**Seven County Infrastructure Coalition's First Supplemental
Response to the STB Office of Environmental Analysis
April 12, 2019 Request for Information # 1**

May 31, 2019

**ATTACHMENT 1:
Uinta Basin Railway Evaluation of Potential Route Alternatives**

Seven County Infrastructure Coalition - Uinta Basin Railway: Evaluation of Potential Route Alternatives

Figure 1: Identified Routes

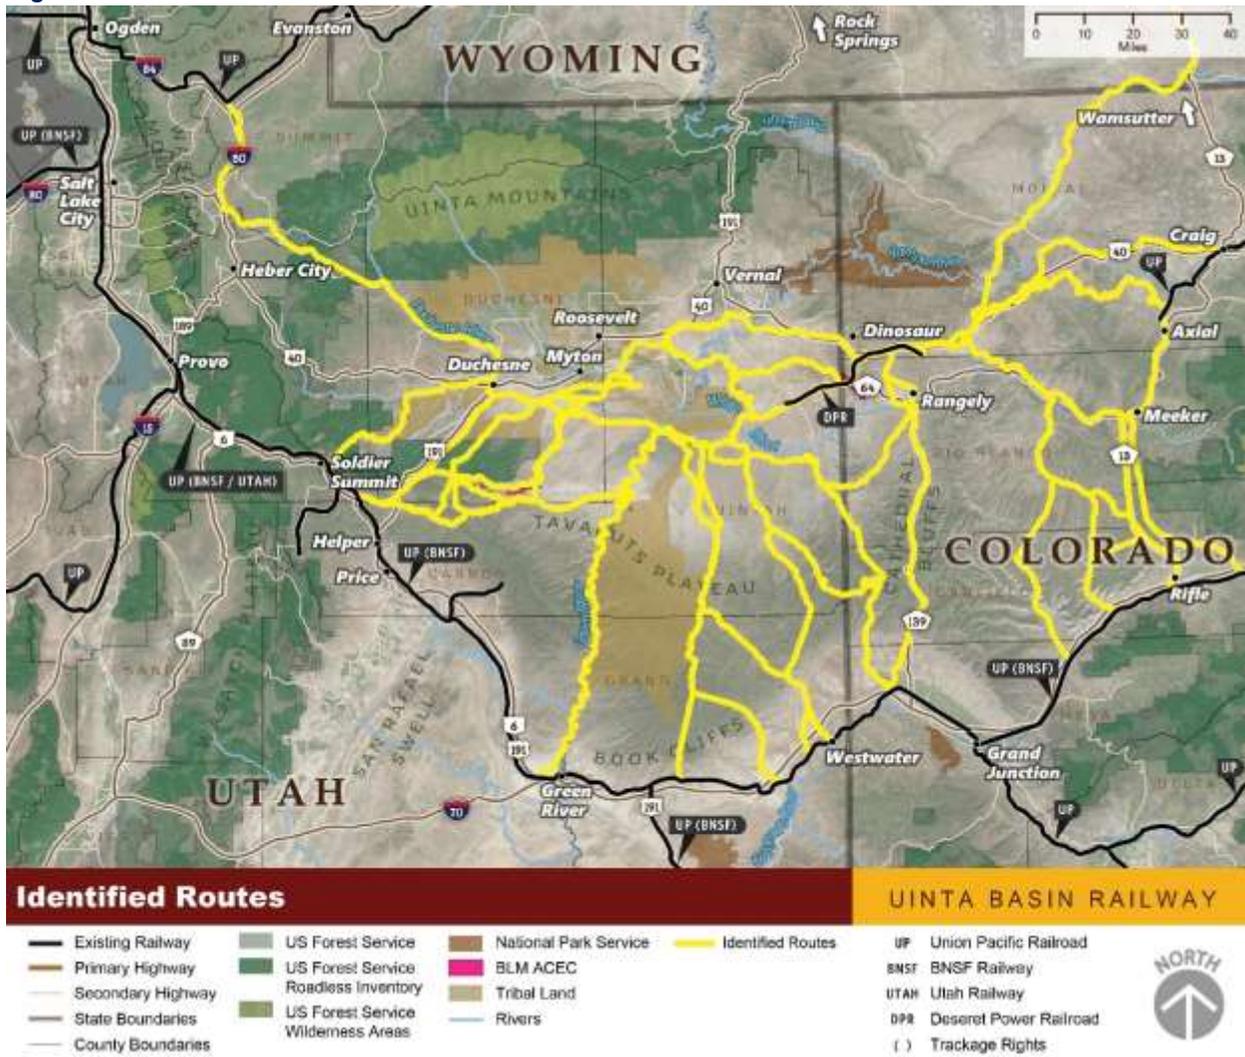
OEA Information Request: *Page two of [the Uinta Basin Railway Evaluation of Potential Route Alternatives] document discusses the rationale for the elimination of 21 routes from further consideration using the four criteria as rationale for dismissal. OEA requests further details, specifying the reason(s) each route was dismissed.*

Coalition Response: Provided as Attachment 1 to this response is an updated version of the *Uinta Basin Railway Evaluation of Potential Route Alternatives* containing additional details regarding the elimination of 21 routes from further consideration in the initial screening process.

After identification of these 29 routes, HDR began the initial screening process. Based on the screening criteria developed for the project, 21 routes were removed from further consideration as they (1) did not meet the operating parameters established in the Operating Basis of Design; (2) had a significantly higher cost of construction, compared

1. Echo: Failed in Natural and Built Environment Effects Screen. This route passed through extensively developed residential areas in the Park City, Utah, area, and would likely have required relocations of residences or effects on numerous residences.

11. Westwater-Seep Ridge: Failed in Not Substantially Duplicative Screen. The route is essentially identical to another route (the Westwater Route) but with higher constructability challenges due to cross-drainages on Seep Ridge.

17. Craig City: Failed in Not Substantially Duplicative Screen. The route is essentially identical to another route (the Craig Route) but with higher constructability challenges, and greater natural and built environment effects, due to it meeting the national railway network within the City of Craig.

24. Axial-Meeker: Failed in Not Substantially Duplicative Screen. The route is essentially identical to another route (the Craig Route) but with higher constructability challenges and greater natural and built environment effects, particularly in the vicinity of Meeker and along the White River.

Figure 2: Routes Carried Forward for Further Evaluation

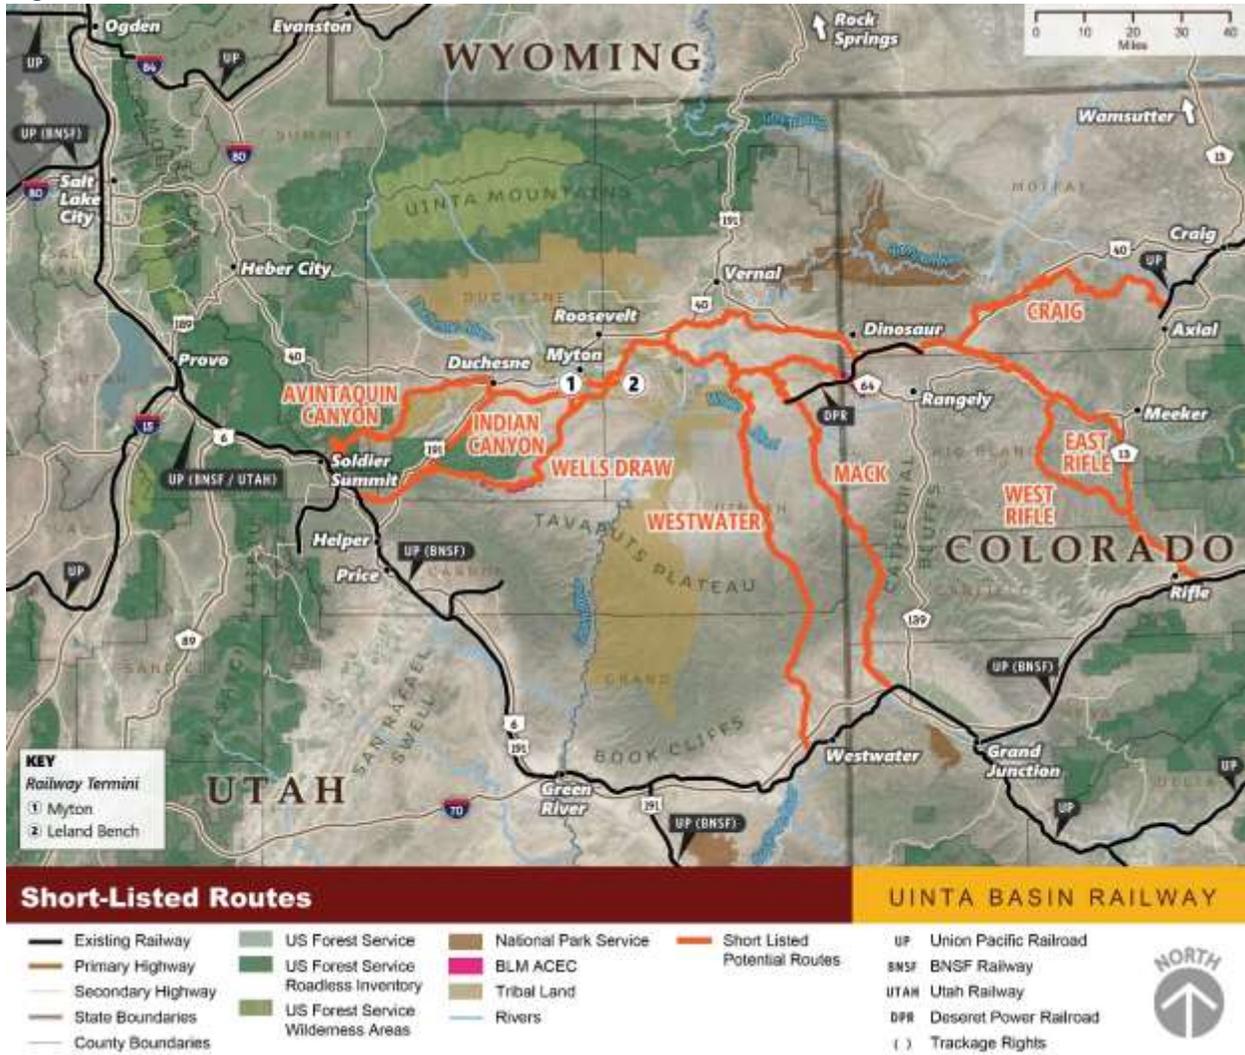
OEA Information Request: *On pages six and seven [of the Uinta Basin Railway Evaluation of Potential Route Alternatives document], the Coalition discusses the collection and analyses of environmental, land ownership, and land use data for eight routes and concludes that, "Based on this preliminary comparison, no route was identified as having significant advantages over any of the other routes from an environmental perspective." Please provide the GIS data and other information used in the alternatives screening process.*

Coalition Response: The GIS data requested was provided to OEA on March 19, 2019. Additional detail regarding the environmental screening factors used in the secondary screening process to compare the eight remaining routes is presented in Table 4 of the revised *Uinta Basin Railway Evaluation of Potential Route Alternatives* (Attachment 1).

Taking into account all of these screening factors, HDR conducted the next step in the process of screening to winnow down the 8 routes. The following findings were made resulting in the identification of 3 routes for the Board’s consideration:

1. The Indian Canyon and Craig routes were determined to be the most feasible from an engineering and design perspective and are the most economical routes to construct, operate, and maintain. However, Indian Canyon would allow for connection to two Class I rail carriers, while Craig would provide a connection to only one.

2. The East Rifle, West Rifle, Mack, and Westwater routes were eliminated from further consideration because they are less feasible from an engineering and design perspective (*i.e.*, go through substantially more Rugged Terrain) than the other routes, cost substantially more to construct than the Indian Canyon and Craig routes, and do not any provide any significant environmental benefits or advantages.

3. The Avintaquin Canyon Route was eliminated from further consideration because it is less feasible from an engineering and design perspective (*i.e.*, goes through substantially more Rugged Terrain) than the other routes, costs substantially more to construct than Indian Canyon and Craig, and does not provide any significant environmental benefits or advantages. The Wells Draw Route, while more costly to construct than the Indian Canyon and Craig routes, does not cross tribal land and avoids U.S. Forest Service lands. For this reason, the Coalition identified Wells Draw for further consideration as well.
